Committee of Adjustment

Report N° PE2026-025

Subject: Minor variance

Civic address: 314, 318 and 322 Turquoise Street, Rockland

Image 2 – Site plan of the initial concept with a markup showing the wider proposed driveway to 8.1 m instead of the initial proposed width

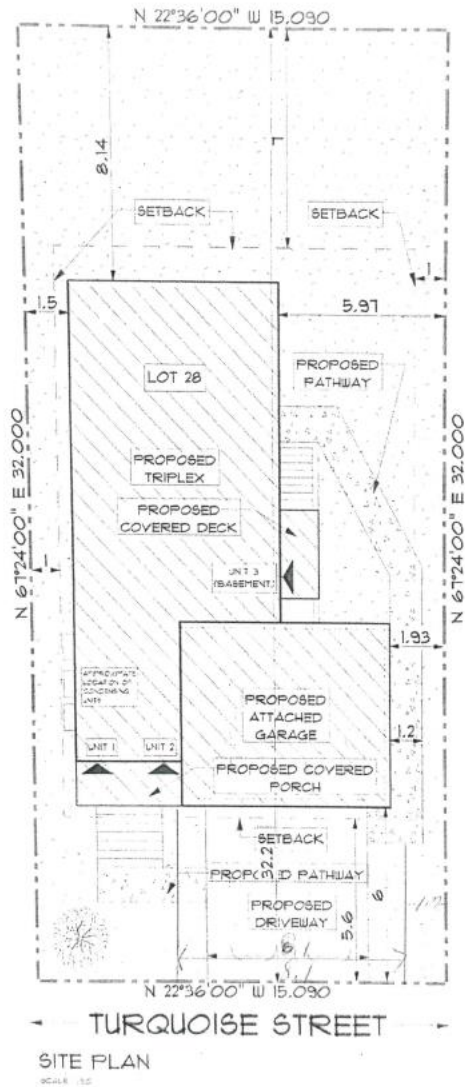
- A landscaped buffer of at least 1.0 meter shall be maintained between any aisle, driveway, surface parking area or lane and any side or rear lot line, in accordance with Section 5.9.1 of Zoning By- Law No. 2016- 10.

- The owner shall plant at least one shade tree in the front yard per lot (plus 2 in side yard if corner lot), of a type required by the City Engineer, in accordance with Schedule "J", within six (6) months of the issuance of the final building inspection, as per Section 39 of the subdivision agreement.

- The driveway shall be paved in accordance with Section 47 of the subdivision agreement.
- The existing watermain standpost shall remain visible and functional at all times.

- Water and Sewer Services Department provided a similar comment, noting that the location of the water service curb stop valve must remain accessible.

- Public Works noted concerns regarding increased hard surface leading to greater snow volumes and reduced snow storage space. Snow shall not be stockpiled or pushed onto the roadway.

The applicant is requesting a minor variance to increase the maximum driveway width from 7.0 metres to 8.1 metres. Four (4) parking spaces are already provided on- site in accordance with the Zoning By- law requirements for a single- detached dwelling with two additional residential units (two (2) spaces for the principal dwelling and one (1) space for each ARU).

The requested increase in driveway width is intended to improve the functional layout of the parking area by allowing each unit to be provided with an individual parking space having direct access to the street. The proposed width of 8.1 metres corresponds to three standard parking stalls of approximately 2.7 metres each, eliminating the need for tandem parking or shared access.

The proposed widening improves site functionality and maneuverability, reduces potential vehicle conflicts, and minimizes reliance on on-street parking. Required landscaped buffers will be maintained, and municipal comments related to infrastructure, servicing, and snow storage must be addressed.

- Increase the maximum permitted driveway width for each lot from 7.0 metres to 8.1 metres.
